NORTH FALLS

## Draft Marine Mammal Mitigation Protocol (Tracked)

Document Reference: 7.7

Revision: ~~120~~

## **Appendix B. Plots for Comparable Hammer Strike Energies**

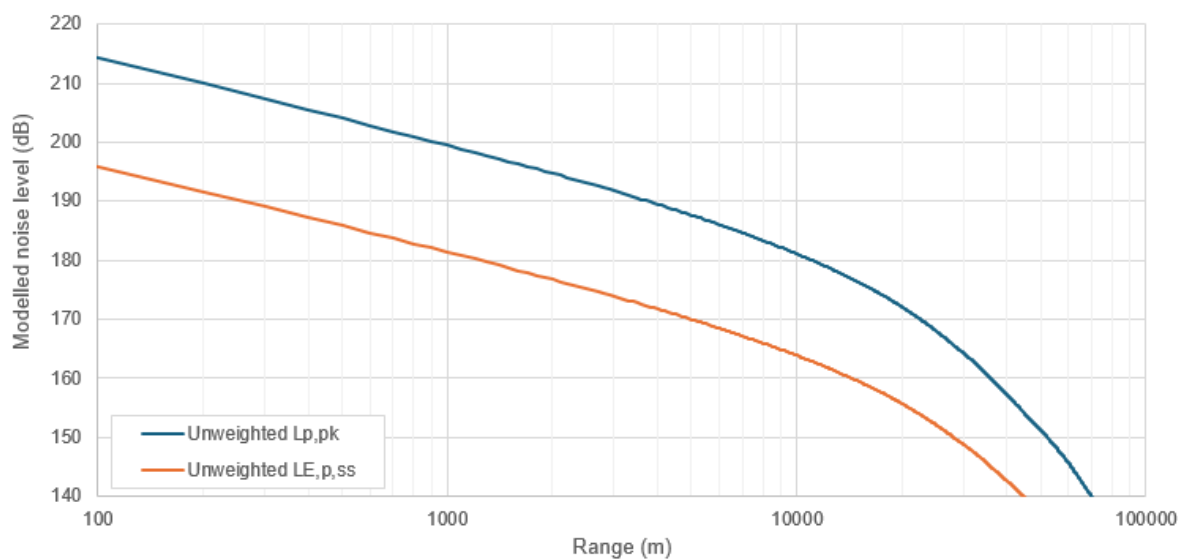
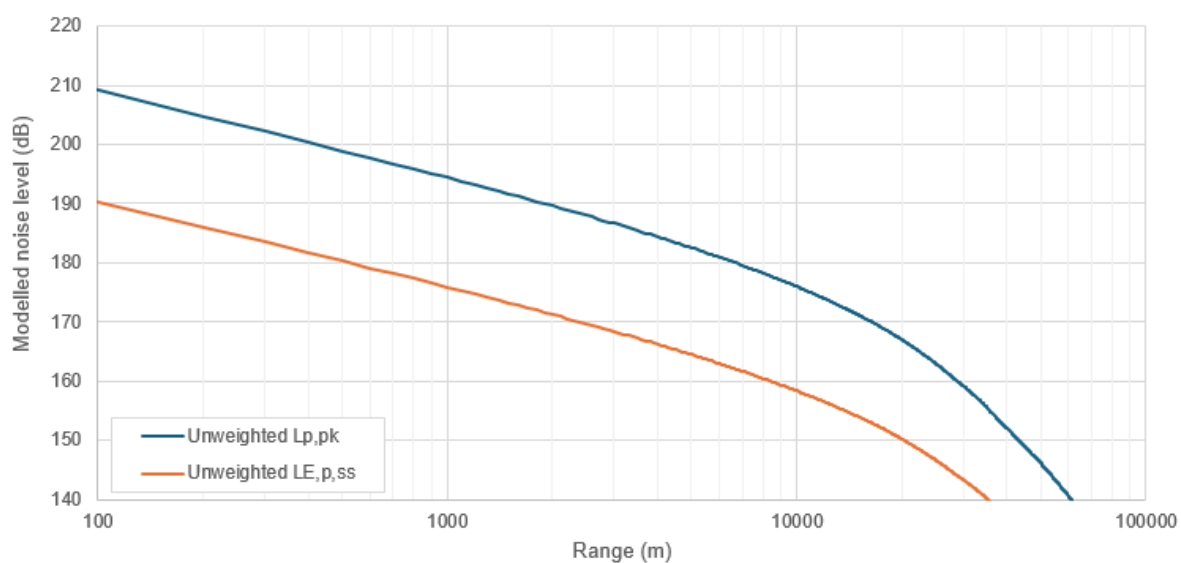
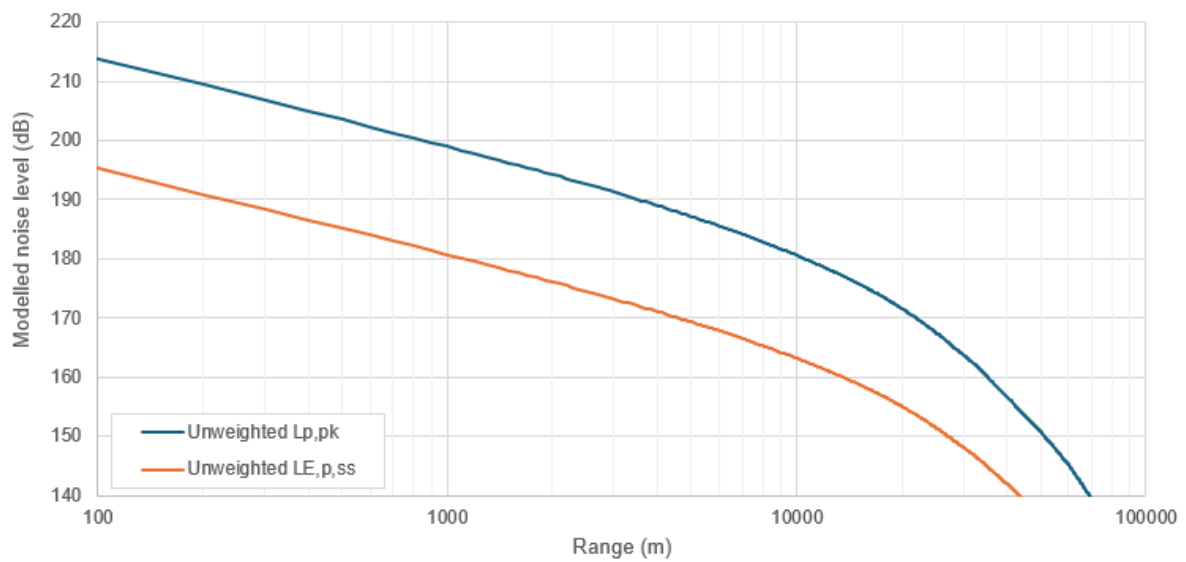
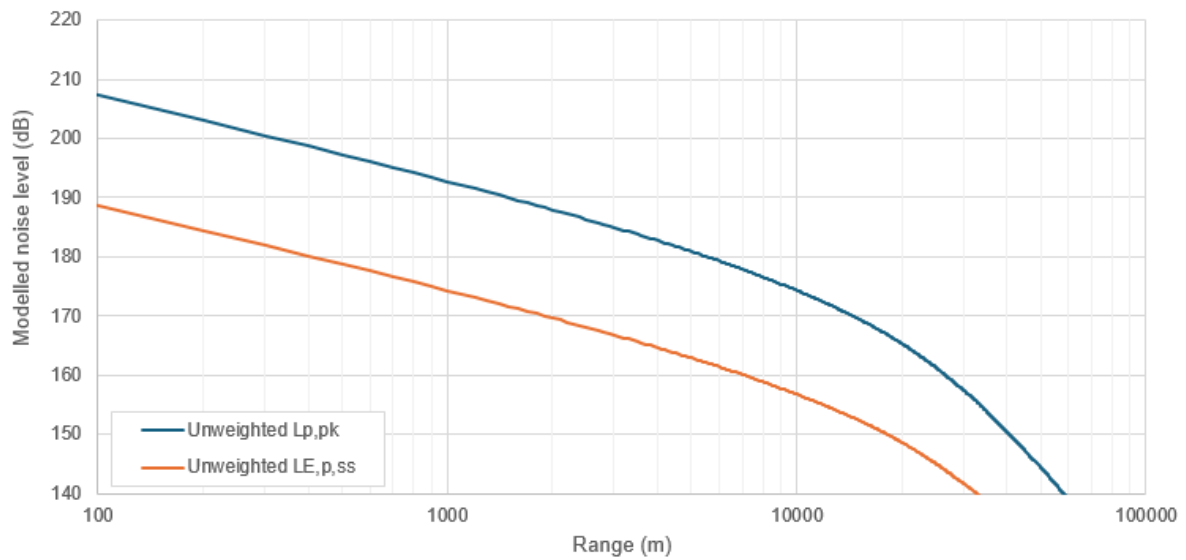
<u>Consultee</u>	<u>Reference</u>	<u>Comment</u>	<u>Response / where addressed in the MMMP</u>
		the final MMMP. The MMO suggests that the Applicant consults with the specific UXO contractor to determine the appropriate parameters for safely deploying bubble curtains. If environmental conditions are not conducive to the use of a bubble curtain, then the MMO recommends postponing any high-order detonations until conditions are suitable.	
<u>MMO</u>	<u>MMO-195</u>	The purpose of the noise monitoring during construction is to determine the actual underwater noise levels on site for comparison with the modelled levels presented in the ES. The MMO acknowledges that the measurements taken during installation will be constrained by various factors such as the piling plan and site limitations and a direct (like-for-like) comparison with a modelled scenario is unlikely to be possible. Nevertheless, even if the piling locations and choice of transects would not be matched precisely, both modelling and monitoring should provide enough information to deduce some envelope of received level curves in each case. Thus, some sort of comparison/s in the form of 'level vs range' plots (for comparable hammer strike energies), with the associated envelopes of variability, should be possible and would be expected. Therefore, the MMO recommends that such a plot is provided.	The Applicant has noted this comment from the MMO, therefore, these plots have been provided in Appendix B as part of this revised Draft MMMP (Revision 21).
